# Waterfront – Main Corridor North of Union St

## Meeting Summary

**September 18, 2014****2:30 – 5:00 pm****Type**CIP Project  
Waterfront Core Project**Phase**

Schematic Design

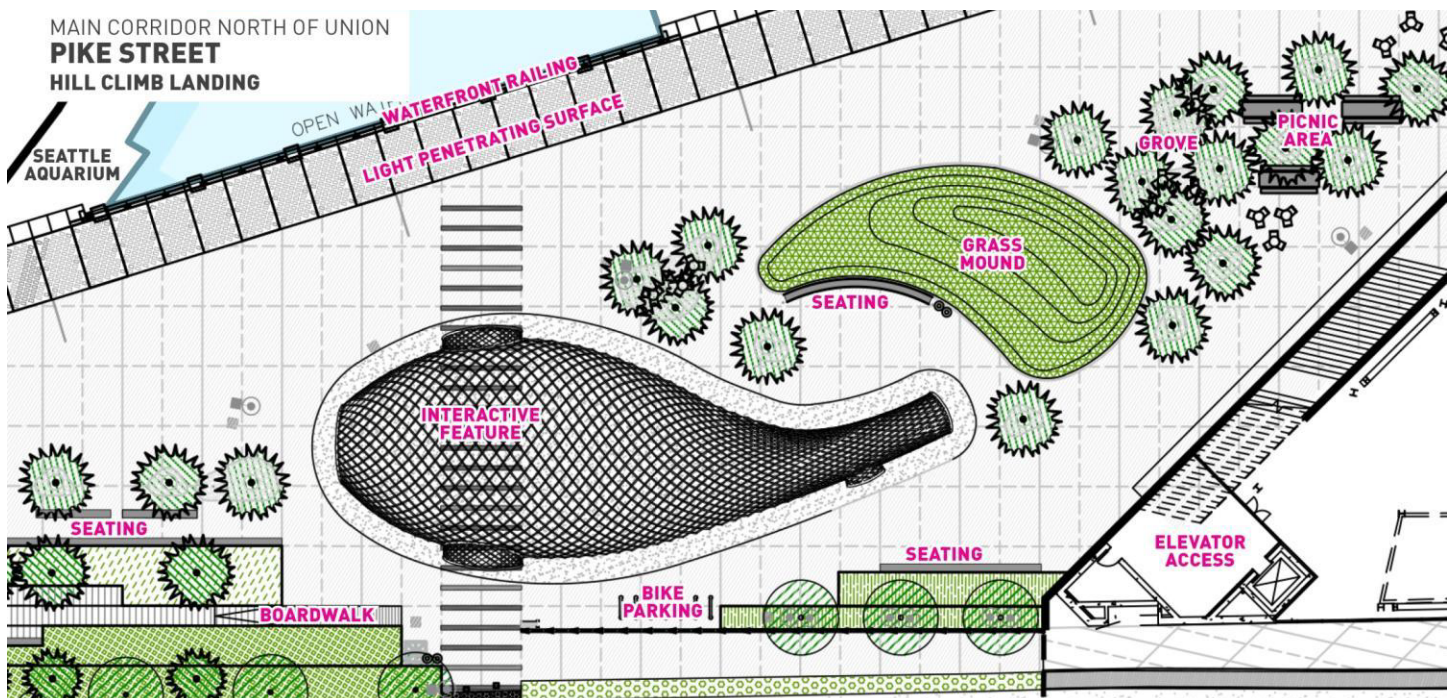
Commissioners were particularly supportive of the use of salvaged wood for the promenade railings and the potential reuse of the sign bridge over the Alaskan Way Viaduct. They suggested keeping the existing signs on it. They appreciated edge treatments along Elliott Way like the proposed planter boxes but cautioned that, if not given adequate attention and care, they could end up marginalized and liable to collect trash.

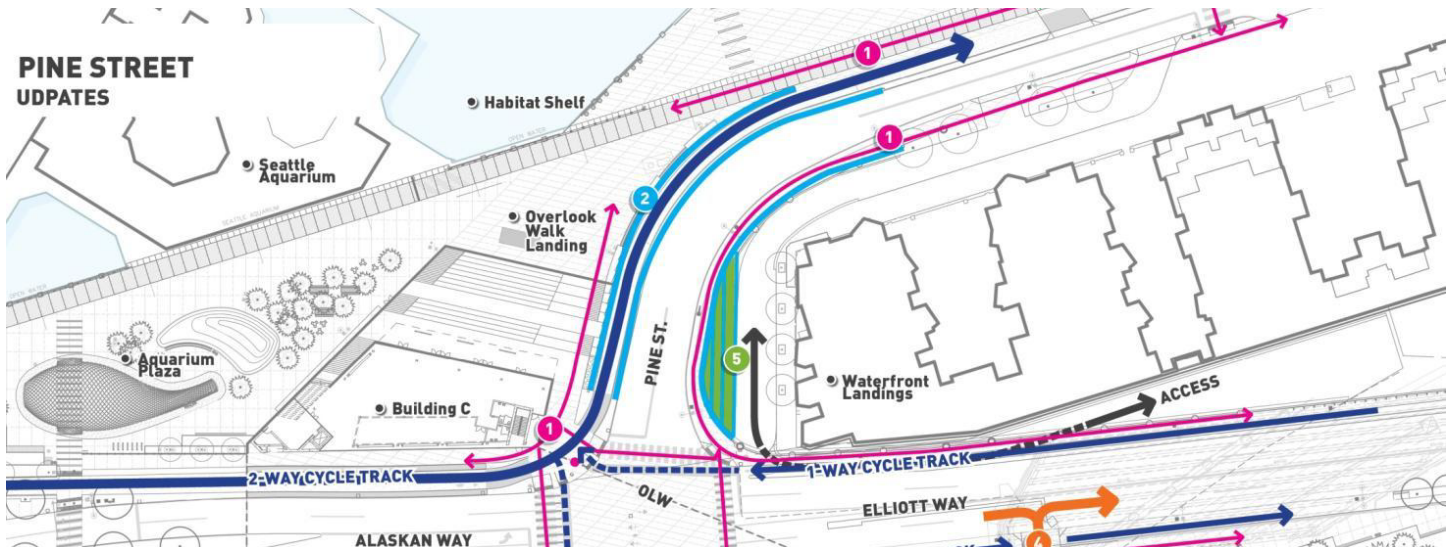
3. Explore additional opportunities to integrate salvaged material into the design as you have with the promenade handrails.
4. Study the number and placement of objects in Aquarium Plaza (below). Give more space around them rather than crowding this zone. Consider transitioning these objects into one another as you have successfully with paving treatments.

5. There is some uncertainty among the Commission about the fish sculpture (right) and a desire to understand its form and design in more detail. Do not let the fish sculpture preclude the opportunity for art to be fully integrated into the design for Pier 62/63 and the Central Public Open Space.

8. On Pine St, show more detail about how the cycle track and retaining walls transition at Alaskan Way near the light penetrating surface functionally, materially, and formally (below). The separation of cars and bicycles on Pine St feels strong and improved in section and elevation. The Commission appreciates that the project team has considered Waterfront Landings in the proposed design.

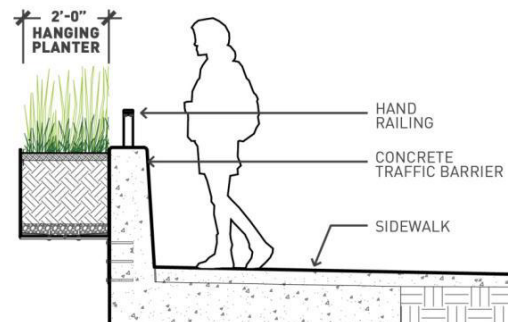
9. The one-way cycle tracks on Elliott Way are an improvement over the previous configuration. Take care when detailing important elements like the planter boxes along the edge of Elliott Way (below right) so they do not become marginalized or prone to collecting trash.
10. Be diligent in choosing, evaluating, and prototyping materials and coatings for durability and effect.
11. While the Commission recognizes the uncertainty about the future of the Lenora Street Bridge, the existing plantings are valuable given their scale and should be retained if at all possible.
12. Continue to develop direct, usable connections at Blanchard St, which has improved significantly from concept design (below). The potential development parcel could be an opportunity to serve latent community needs and might be less valuable as open space given the nearby portal site at Battery St.
